ADDENDUM #1
NEW SANCTUARY FOR ST. ELIZABETH CPCA
104 PERRY ST.
MADISON, AL. 35758

OCTOBER 19, 2017

ADDENDUM #2

DECEMBER 7, 2017

SHEET TITLE:
1ST FLOOR AND MEZZANINE LIFE SAFETY PLANS

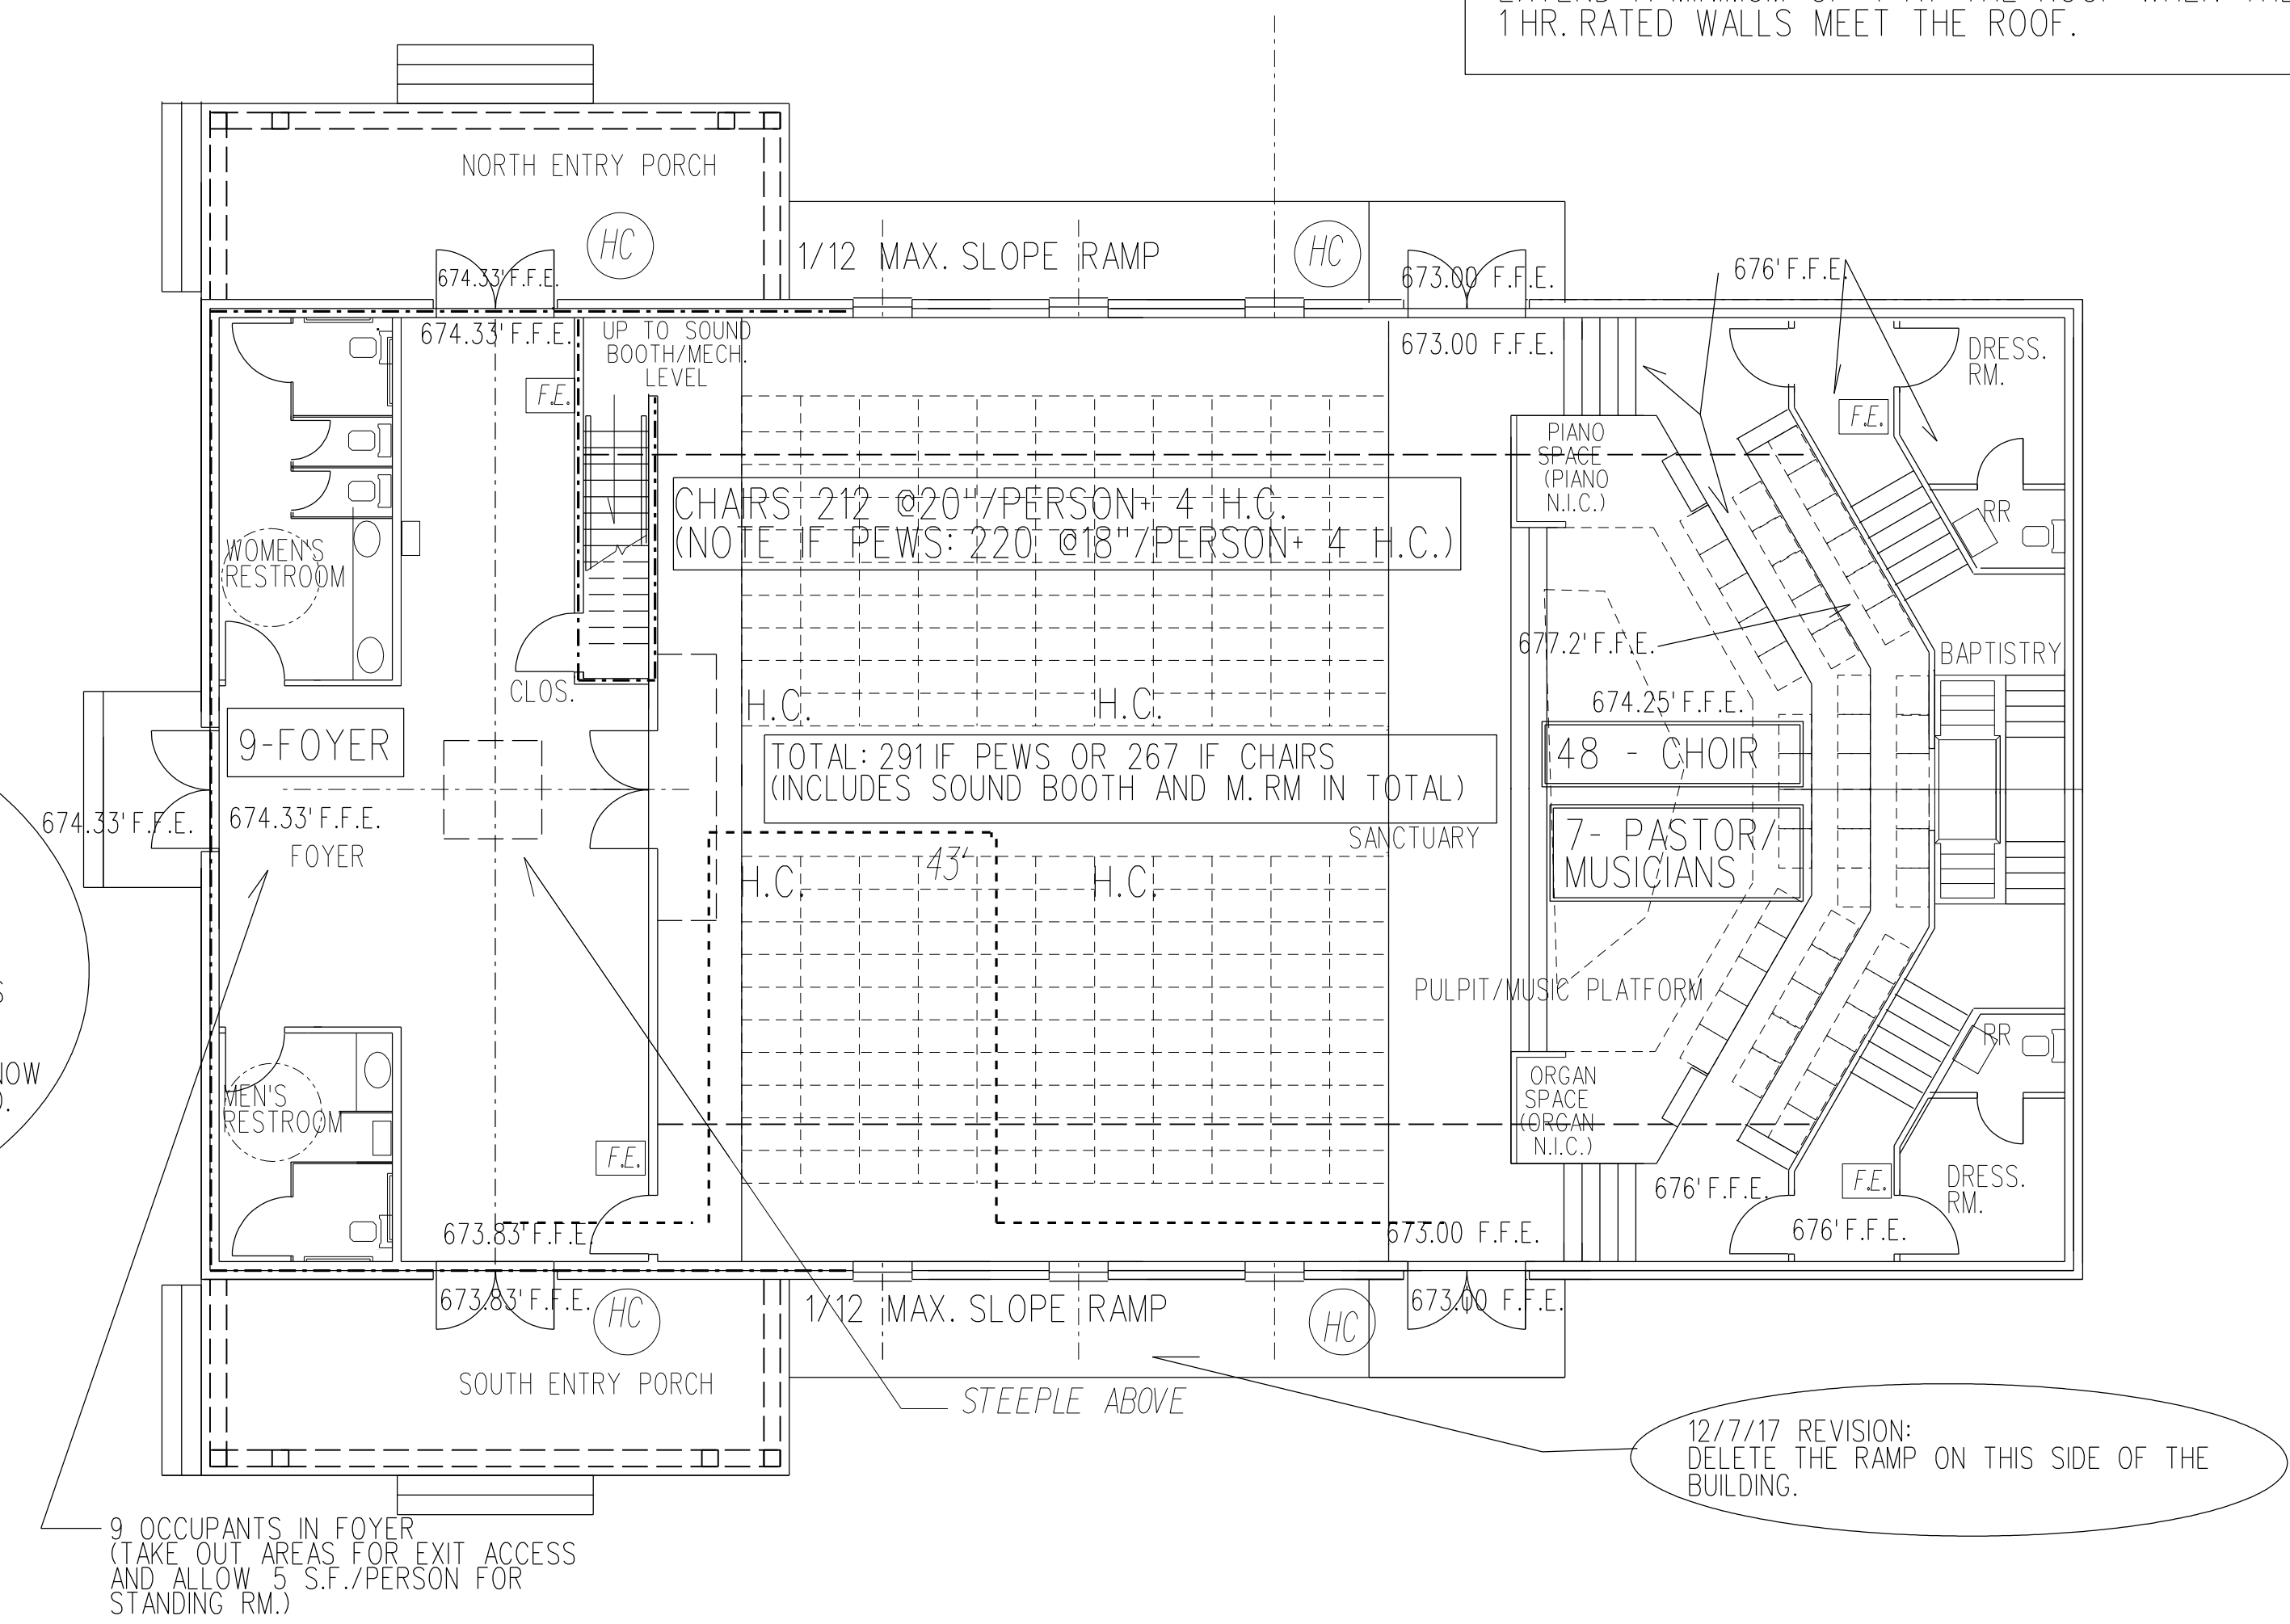
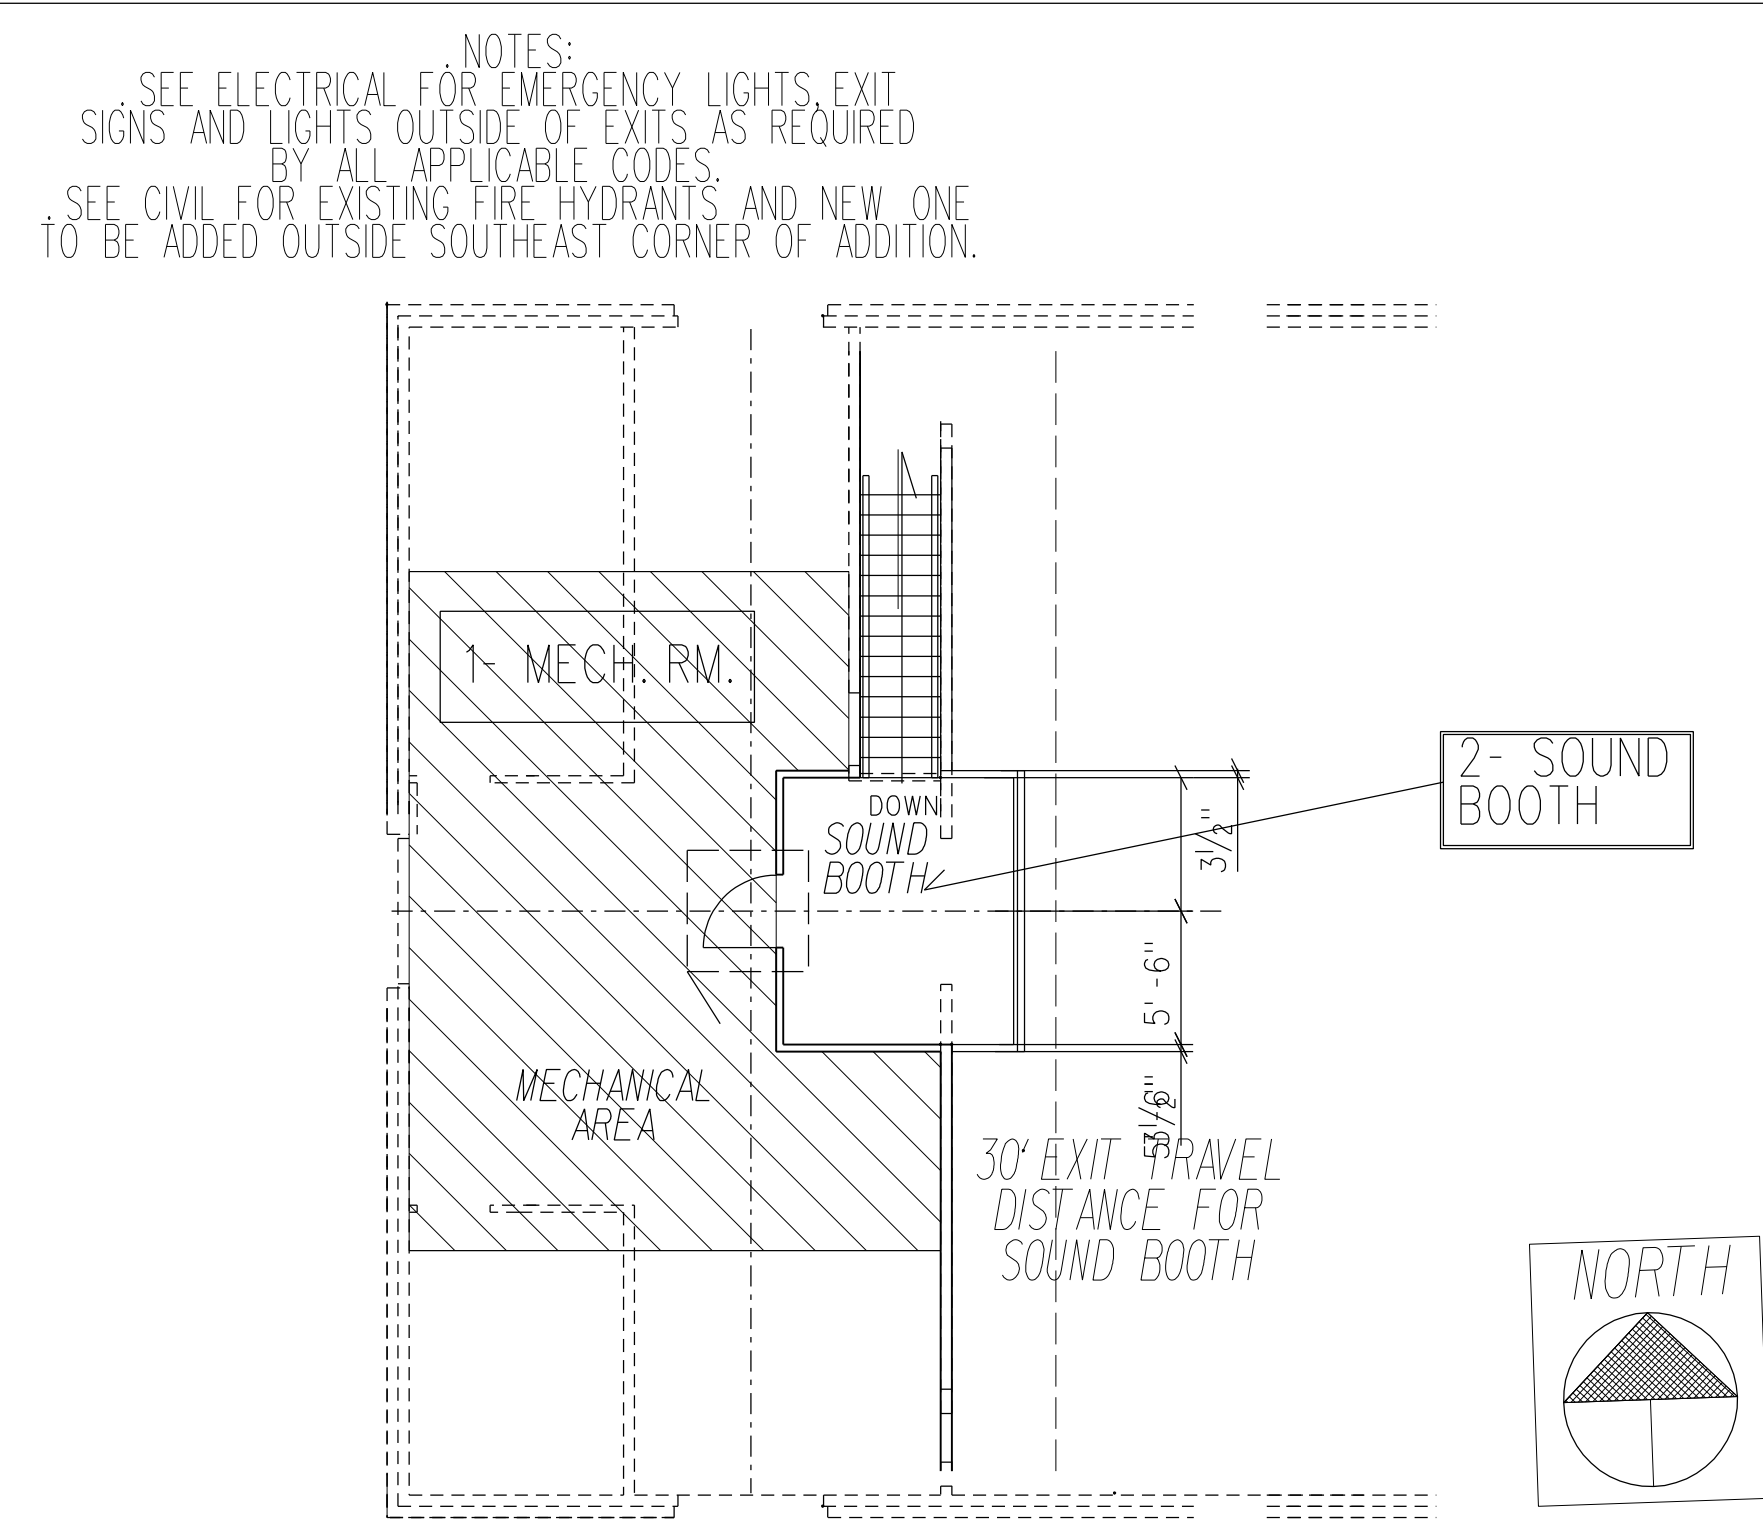
LS1 OCCUPANT LOAD FOR THE FOYER/CORRIDOR SHALL BE 9 INSTEAD OF 7. THERE IS 43 S.F. THAT IS NOT PART OF THE CORRIDOR AND SHALL BE STANDING ROOM AT 5 S.F./PERSON. SEE THE REVISED OCCUPANCY LOADS FOR ADDITION ON REVISED LIFE SAFETY PLAN. THE TOTAL NOW FOR THE ADDITION IS 291 IF PEWS ARE USED IN SANCTUARY AND 267 IF CHAIRS ARE USED. THIS INCLUDES THE MECHANICAL ROOM AND SOUND BOOTH AS WELL AS OTHER AREAS OF THE ADDITION.

12/7/17 REVISION TO OCCUPANT LOAD::
FOYER/CORRIDORS TO HAVE 9 OCCUPANT LOAD INSTEAD OF 7 DUE TO STANDING ROOM AT 5 S.F./PERSON IN 43 S.F. OF THE NON EXIT ACCESS PART OF THESE AREAS.
THE SANCTUARY SEATING WILL BE 220 IF PEWS ARE USED AND 196 IF CHAIRS ARE USED; CHOIR IS 48; PULPIT/MUSICIANS AREA IS 7; SOUND BOOTH IS 2. RECALCULATED TOTAL IS NOW 290 FOR ADDITION OR 266 IF CHAIRS ARE USED.
